UNITED STATES
DEPARTMENT OF THE INTERIOR
BUREAU OF LAND MANAGEMENTFORM APPROVED
OMB NO. 1004-0137
Expires: January 31, 2018**SUNDRY NOTICES AND REPORTS ON WELLS**
*Do not use this form for proposals to drill or to re-enter an abandoned well. Use form 3160-3 (APD) for such proposals.*5. Lease Serial No.
NMNM100549

SUBMIT IN TRIPLICATE - Other instructions on page 27. If Unit or CA/Agreement, Name and/or No.
NMNM1386188. Well Name and No.
HH SO 17 20 FED 002 6H9. API Well No.
30-015-45109-00-X110. Field and Pool or Exploratory Area
PURPLE SAGE-WOLFCAMP (GAS)11. County or Parish, State
EDDY COUNTY, NM

Chevron USA Inc respectfully requests the following changes to the original APD approved 7/6/2018:

Changes to APD/COA for Federal Well

Drilling Sequence & Slot Designation

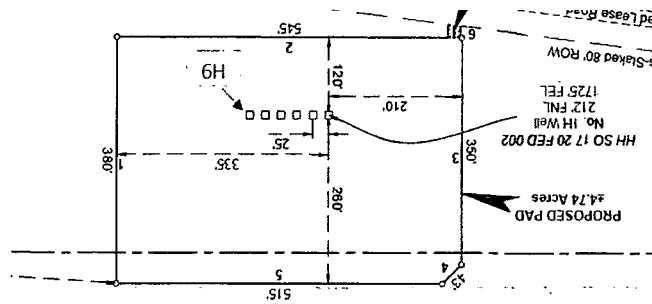
- A variance from the Onshore Order 2 where it states "(A full BOP Test) shall be performed: when initially installed and whenever any seal subject to test pressure is broken." We propose to break test if able to finish the next hole section within 21 days of the previous full BOP test. Upon the first nipple up of the pad a full BOP test will be performed. A break test will consist of a 250 psi low / $\geq$ 5,000 psi high 10 min ea ~~test~~ against the connection that was broken when skidding the rig. A break test will not be performed on our last production section. A break test will only be performed on operations where BLM documentation states a 5M or less BOP can be utilized.

See drilling sequence below that indicates the potential hole sections break testing can be performed given they meet the above criteria.

Option 4 - skid after int 1 and int 2 drilled on each well; skid 5, 3, 1, 2, 5, 4
